TC1766

32-Bit Single-Chip Microcontroller

TC1766 Documentation Addendum

Revision History: **V1.2 2007-04**

Figure 1-12 TC1766 Pinning for PG-LQFP-176-2 Package

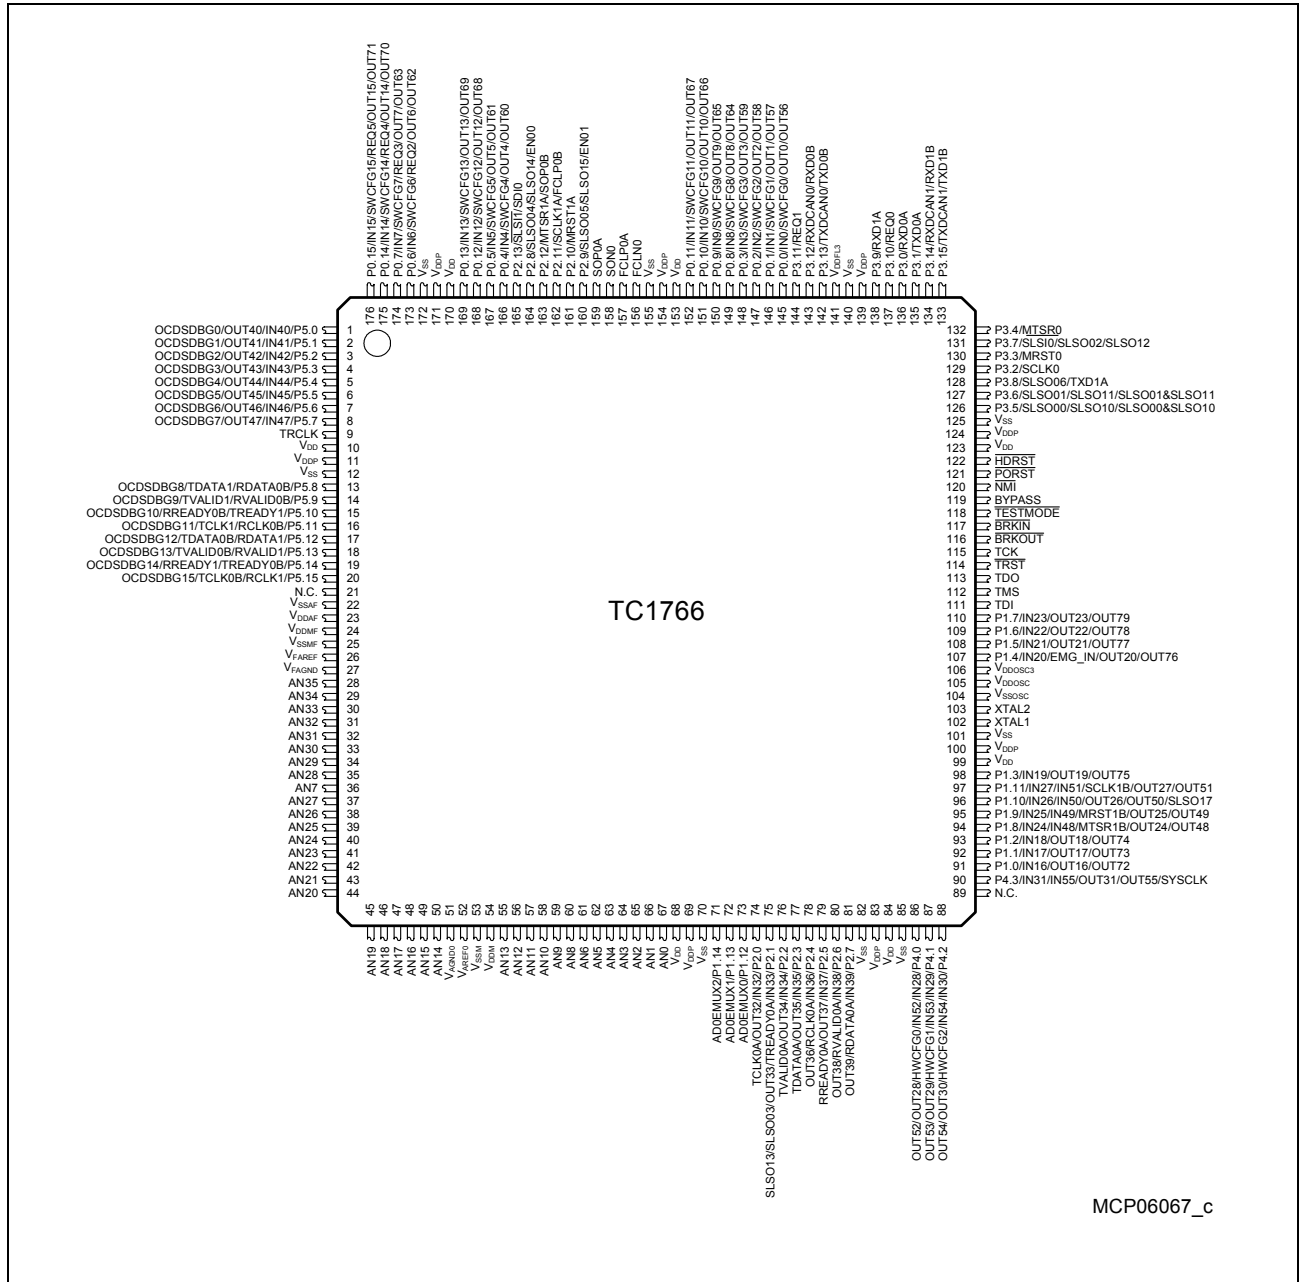
Figure 1-12 should be replaced with the below figure:

Figure 2-11 PMI Block Diagram

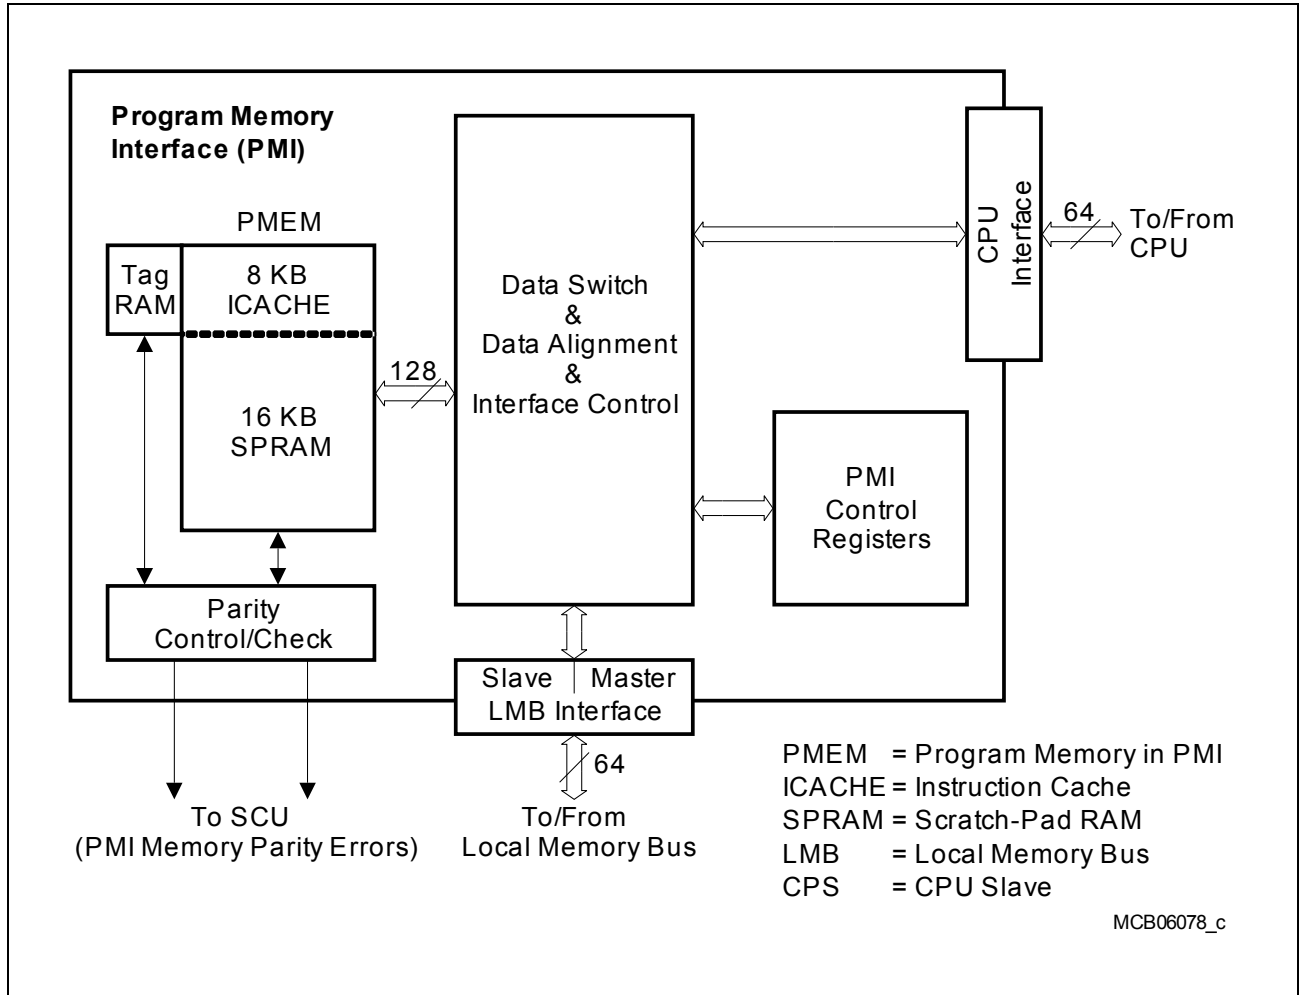
Figure 2-11 should be replaced with the below figure:

Figure 5-11 DMA Request Selection Logic

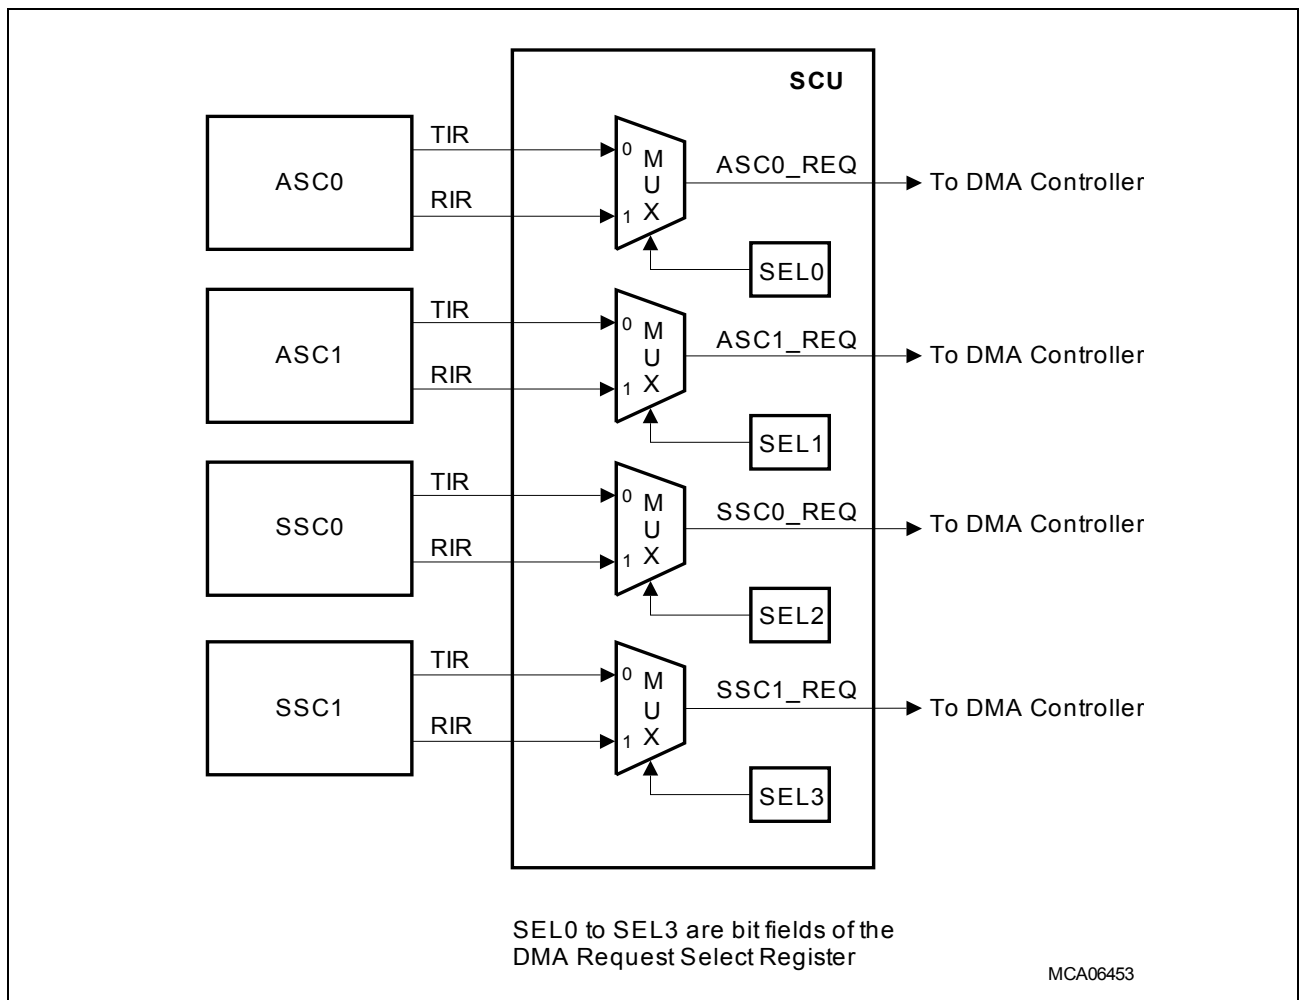
Figure 5-11 should be replaced with the figure shown as below. The below note must be added to the end of the last sentence of the page.

Note: By default, TIR line is selected for both ASC and SSC modules. For RIR line to be selected, SEL0.DMARS to SEL3.DMARS should be set accordingly. See DMARS register.

Figure 6-7 Basic FPI Bus Transactions

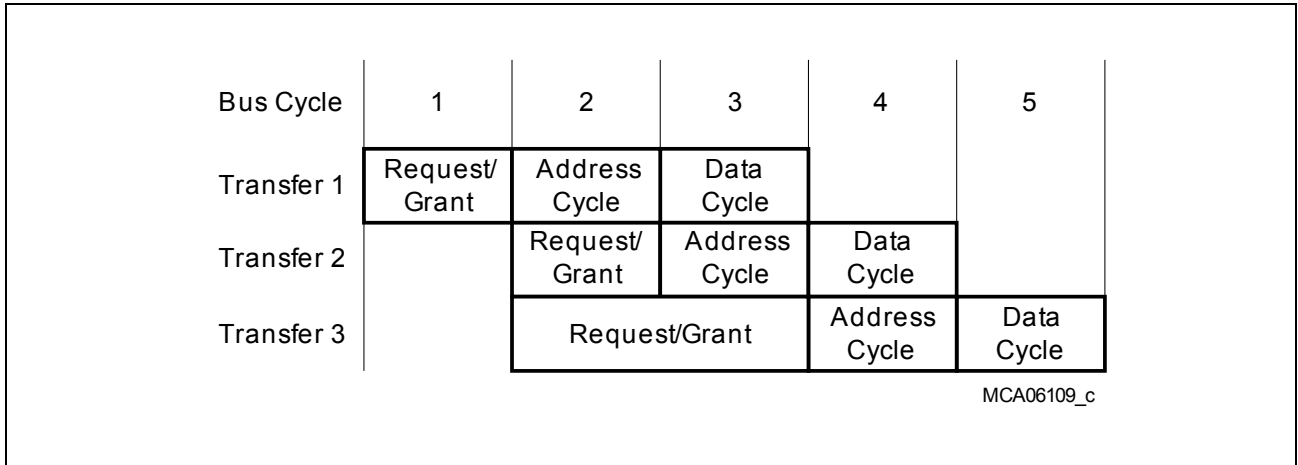
Figure 6-7 should be replaced with the below figure:

Figure 6-12 BCU Breakpoint Trigger Combination Logic

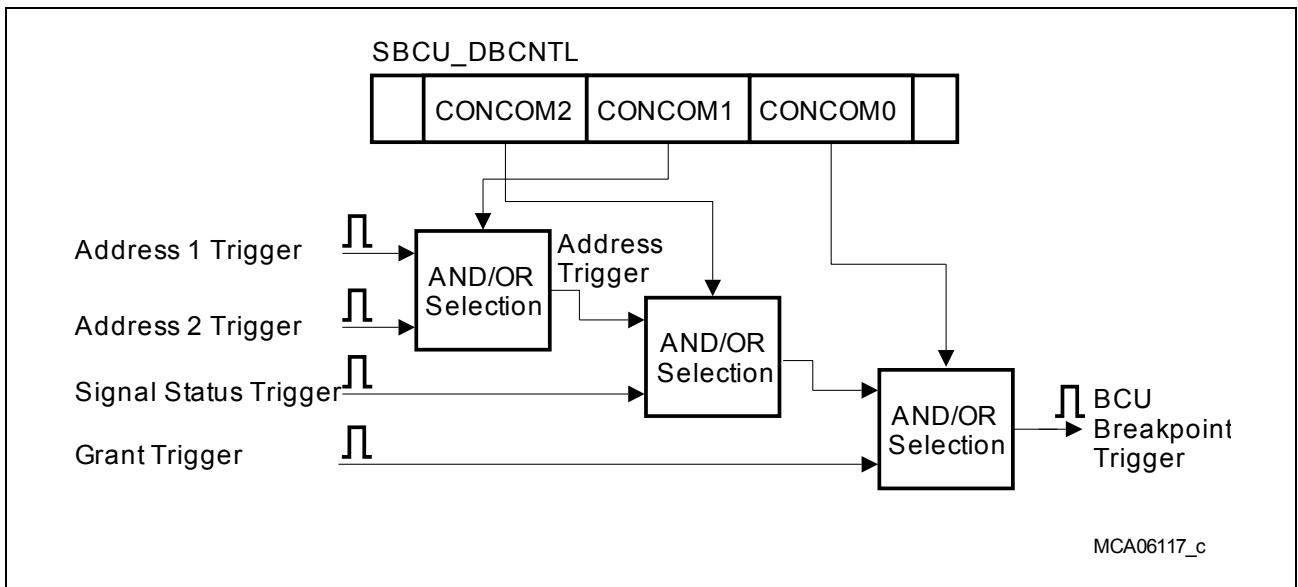
Figure 6-12 should be replaced with the below figure:

Figure 10-14 Counter Operation for BCOPY Instruction

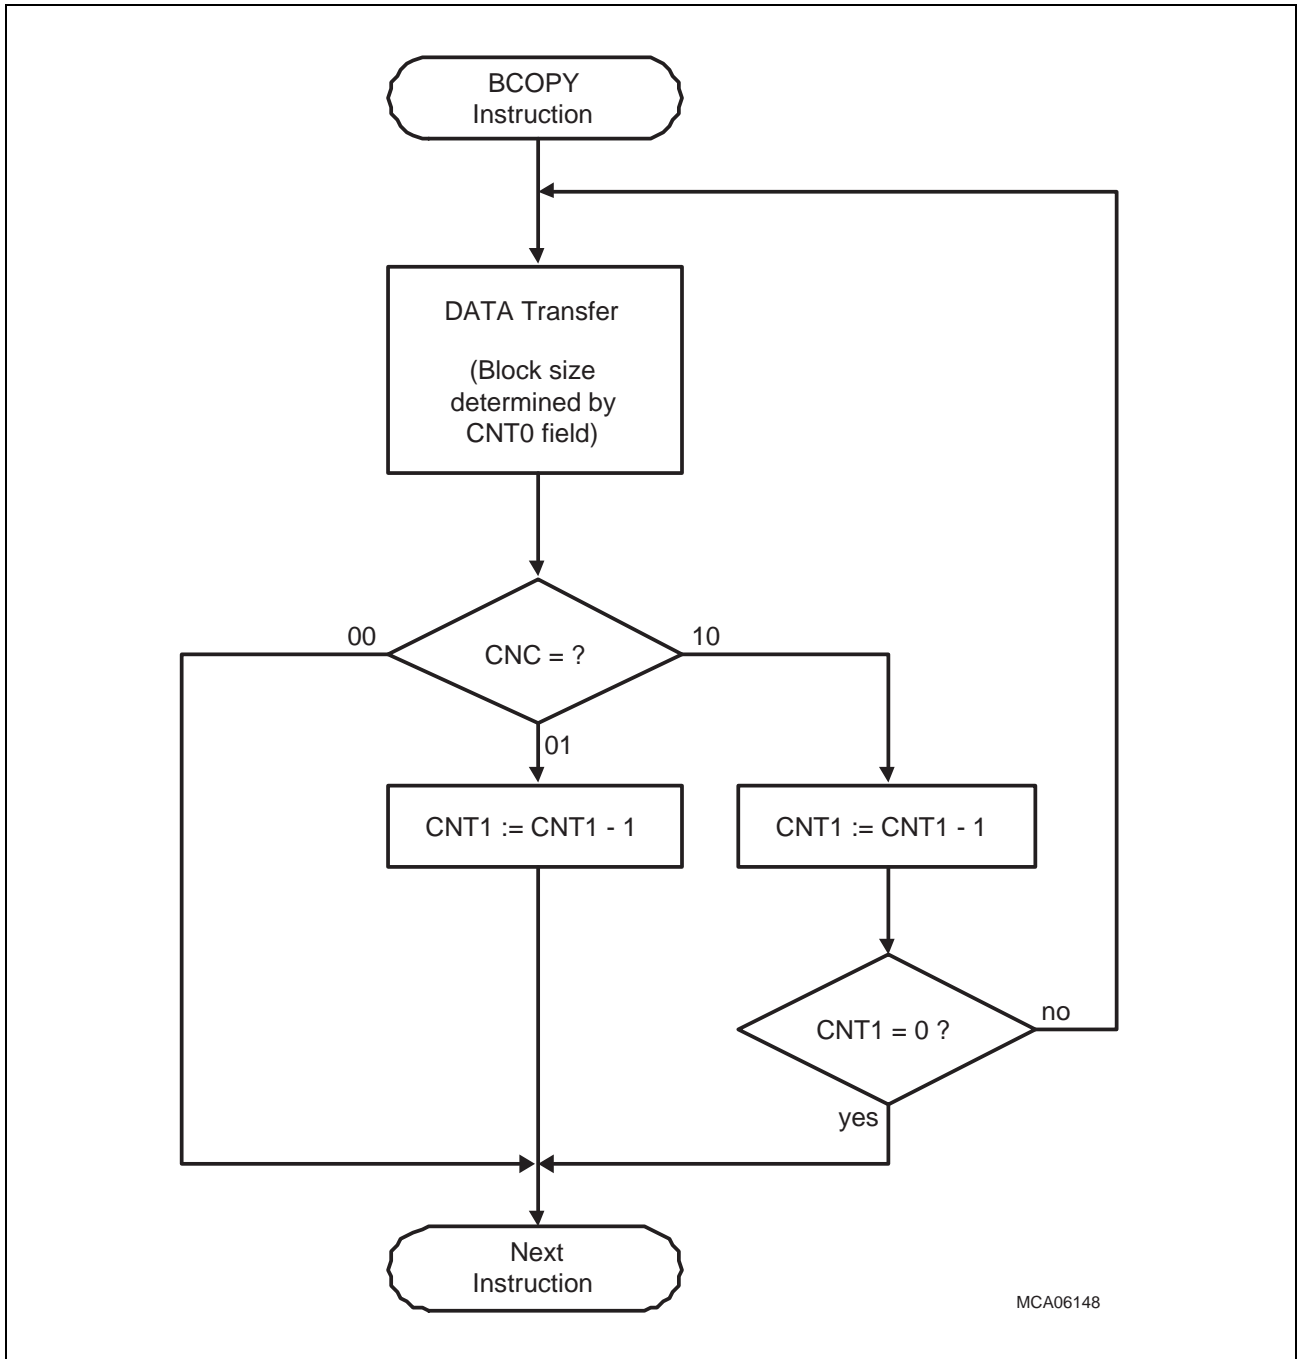
Figure 10-14 must be replaced by the following figure (block "DATA Transfer" has been changed):

Figure 11-5 Shadow Source Address and Transfer Count Update

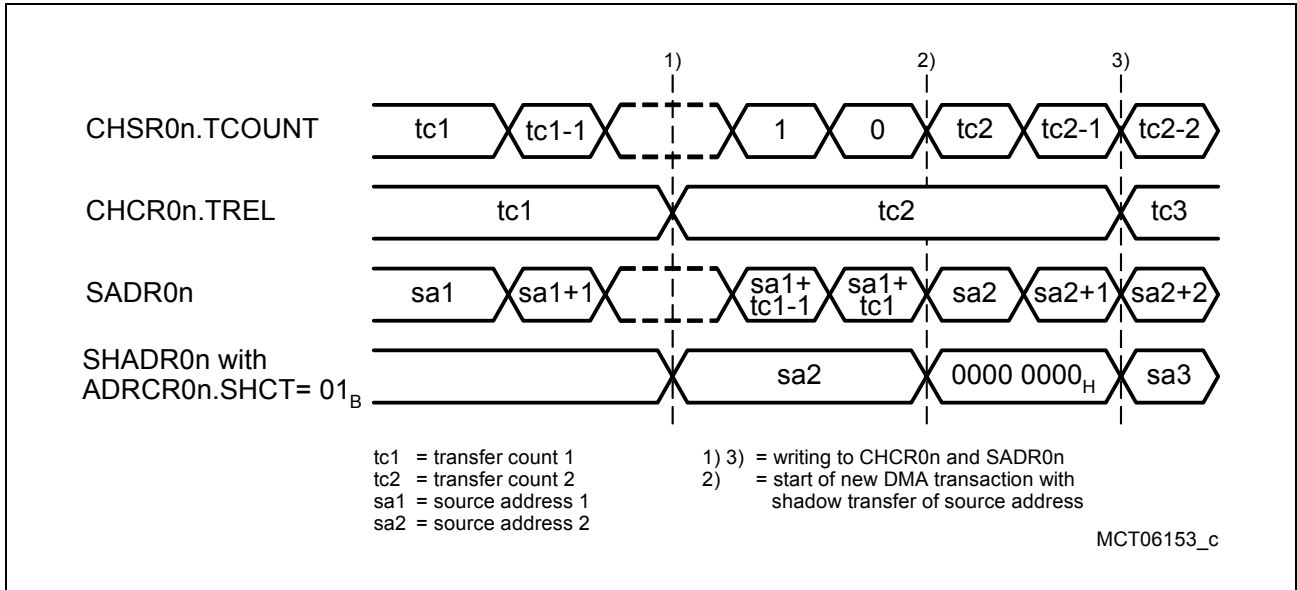
The wordings "SHADR0n with CHCR0n.SHCT = 01_B" on the left of the first waveform from the bottom of Figure 11-5 must be replaced with "SHADR0n with ADRCR0n.SHCT = 01_B".

Figure 11-6 Channel Request Control

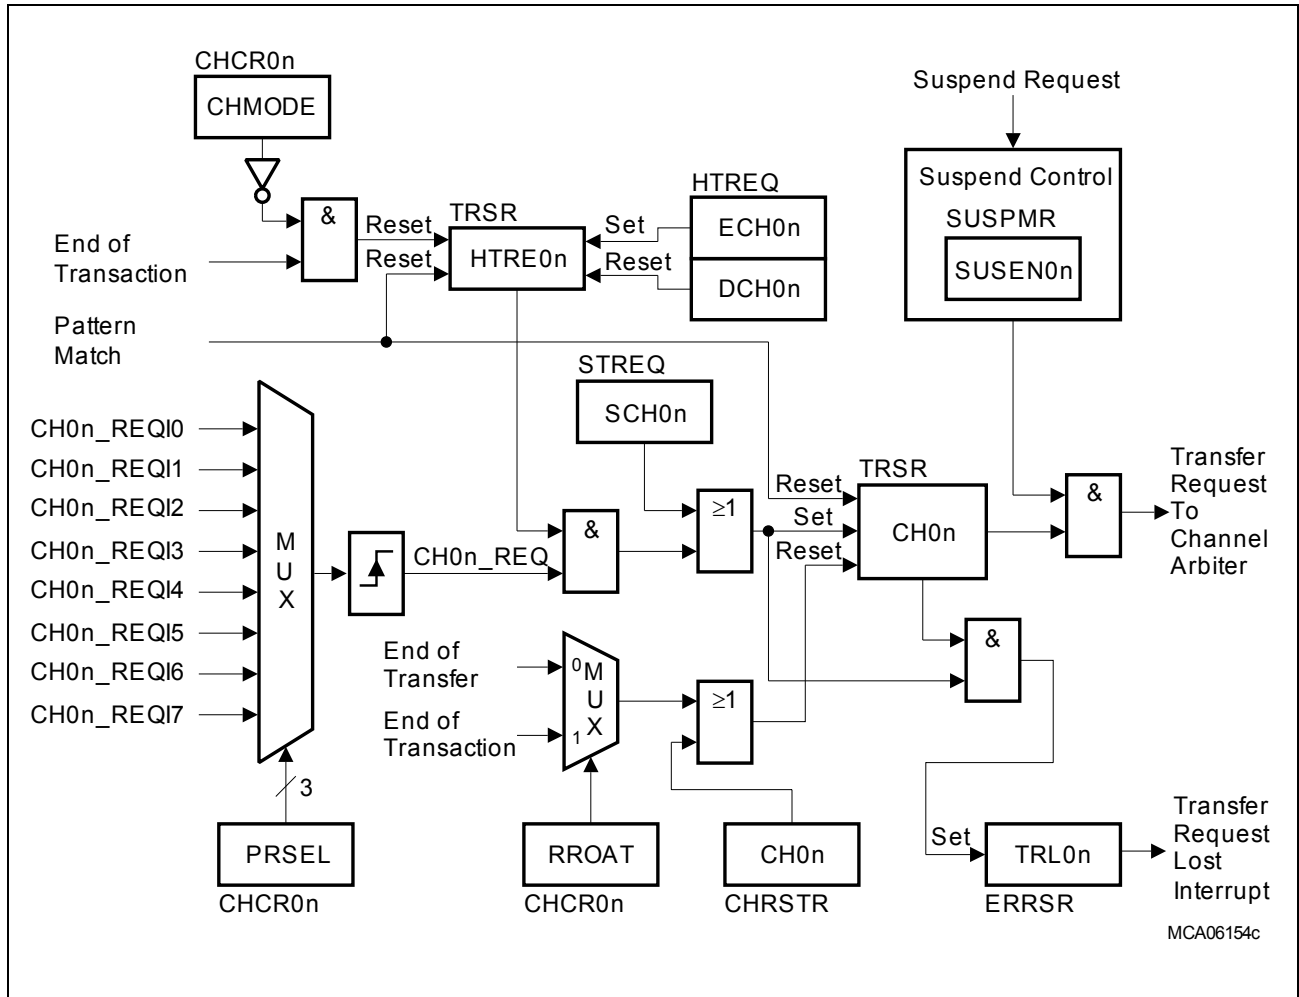
Figure 11-6 must be updated as per the corresponding changes on pages 11-35 and 11-50.

Figure 11-18 Transaction Lost Interrupt

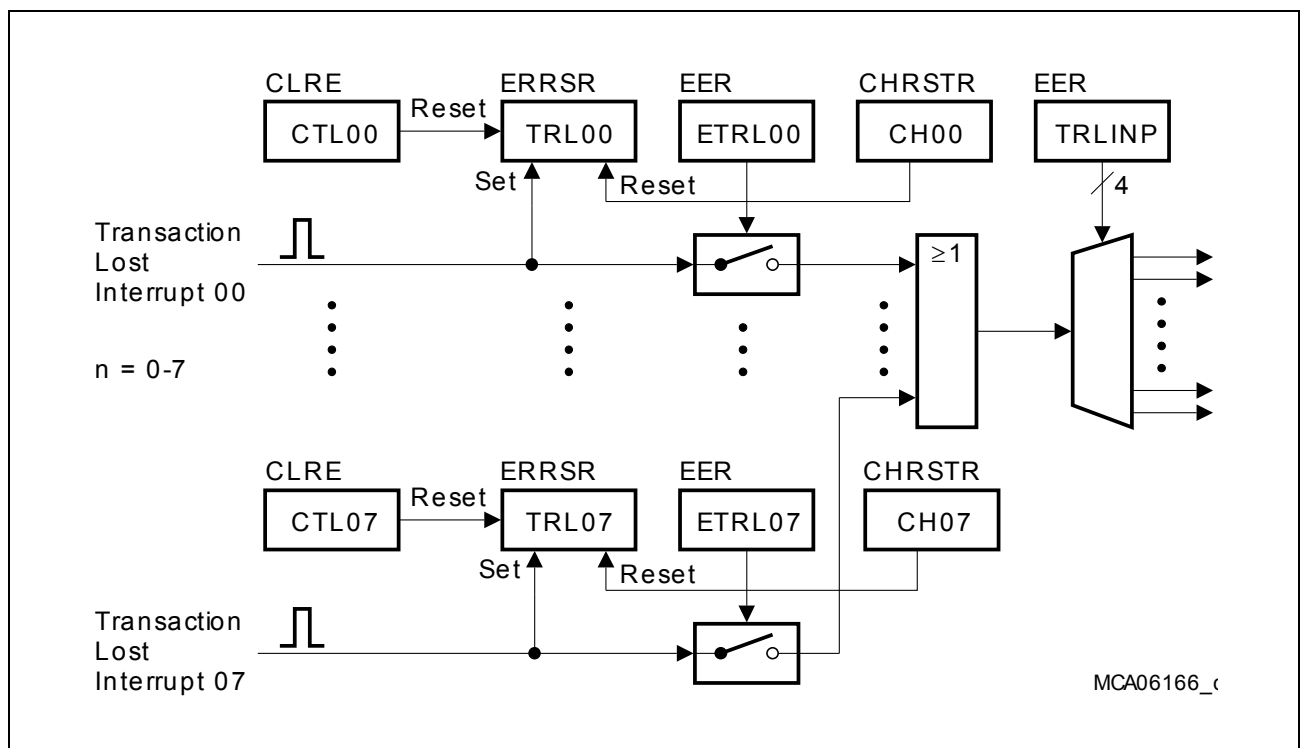
In Section 11.1.8.2, the register name EERSR must be replaced by ERRSR in the third sentence of the first paragraph, first sentence of the second paragraph and within Figure 11-18. The corresponding text must be replaced by :

Figure 11-18 must be replaced by:

“If such a transaction request lost condition occurs, bit **ERRSR.TRL0n** is set.” and “A transaction request lost condition of DMA channel 0n is indicated by status flag **ERRSR.TRL0n**, which can be reset by setting bit **CLRE.CTL0n** or **CHRSTR.CH0n**.”
